## **APPLICATIONS CRC175344 AND CRC175345 – CANTERBURY LANDSCAPE SUPPLIES LIMITED**

## **SUMMARY FOR HEARING APPLICATIONS CRC175344 AND CRC175345 – CANTERBURY LANDSCAPE SUPPLIES LIMITED**

### CANTERBURY LANDSCAPES SUPPLIES AIR DISCHARGE PERMIT APPLICATION

**Subject: Review of potential for groundwater quality impacts from Canterbury Landscape Supplies composting facility**

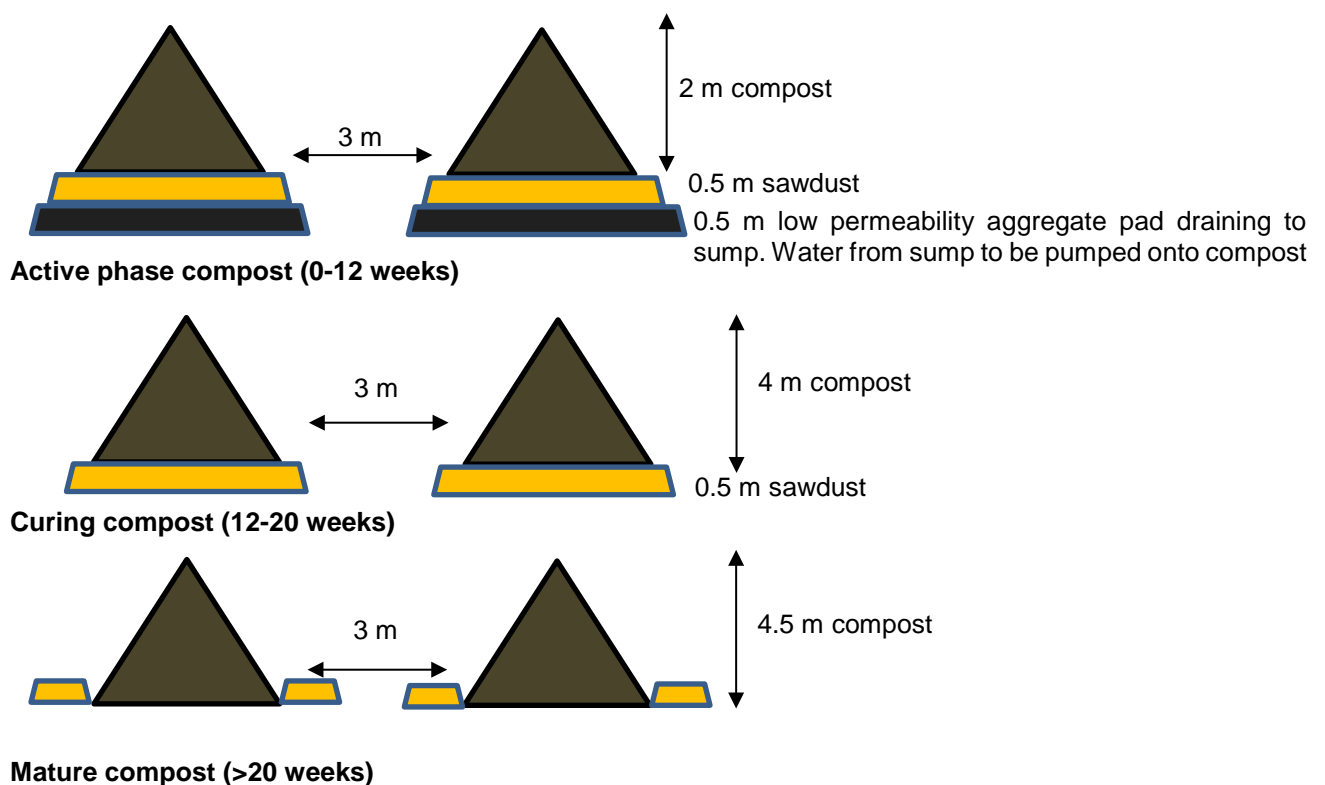
I first reviewed this application in November 2017, at which time I raised questions over some of the assumptions and methods used to model potential groundwater quality impacts. Since that time, I have had a number of useful discussions and meetings with the applicant's consultant (Helen Mongillo, Sephira Environmental) focusing on the adsorptive capacity of the compost and sawdust and the proposed mitigation measures, using sawdust. The proposals for management of compost at the site have also been revised in the run-up to the hearing. I have provided a diagram of the applicant's proposal, as I understand it, below.

It is not clear to me why an aggregate pad is proposed for the active phase compost but not for the curing and mature compost. I appreciate that the risk of nitrogen leaching from this older material is lower, but am not convinced that it is so much lower that a lower level of mitigation is warranted. The risk of taste and odour-causing substances being discharged from this material may be similar to the active phase compost, for instance. Unless the applicant can provide a compelling justification to the contrary, my recommendation would be that all compost stored on the site is managed with the same degree of rigour to avoid leachate discharge to ground.
